# **Stream Flow Monitoring Report - Water Year 2021 – Salmon Creek**

*Annex Creek/Salmon Creek Hydroelectric Project  
(FERC Project No. 2307)*

**Alaska Electric Light and Power Company  
Juneau, Alaska**

**November 12, 2021**

Figure 1 – Fourth Quarter 2020 Corrected Discharge

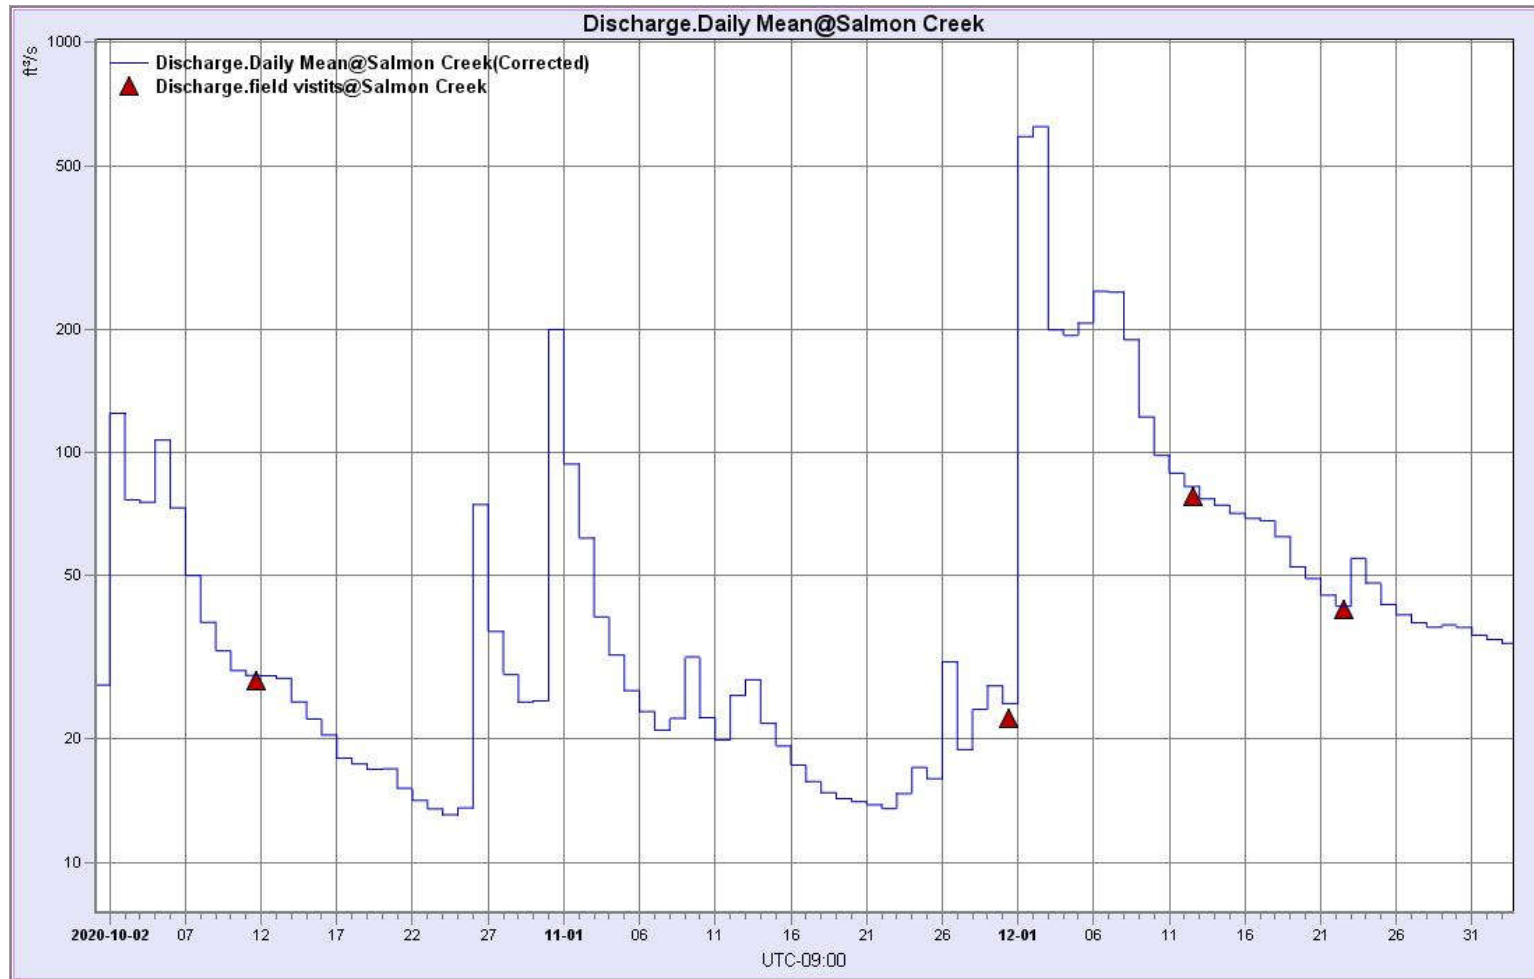
- ADF&G had no comments.
- USFWS had no comments.
- NOAA replied that the report complied with the FERC license and reporting requirements but requested AELP back calculate the flow that occurred on Dec 1-2, 2020.

The FERC license does not require AEL&P to measure or back calculate the highest flow on record that occurred on Dec 1-2 of 2020, but it would be wise to do so. The main mention of this was on page 33. It would be interesting to know if it just barely exceeded the highest flow on record of 2110 cfs from 2005, or if it exceeded it by 500 cfs or more. Without a value for the Dec 1- 2, 2020 flow it is difficult to develop accurate flood frequency curves. The closer AEL&P can come to defining that flow the better handle AEL&P can have at defining the 10-year, 20-year, 50 year and 100-year recurrence event.

AELP Response: The purpose of the streamflow monitoring plan is to provide minimum flows for fisheries in the lower reach of the stream. The NMFS comments recommended back-calculation of the high flow period on December 1-2, 2020 but noted that this is not a requirement. Since Salmon Creek is a regulated basin with both 100 year and probable maximum flood analyses completed for the project, AELP does not have any operational reason to complete these calculations at this time.
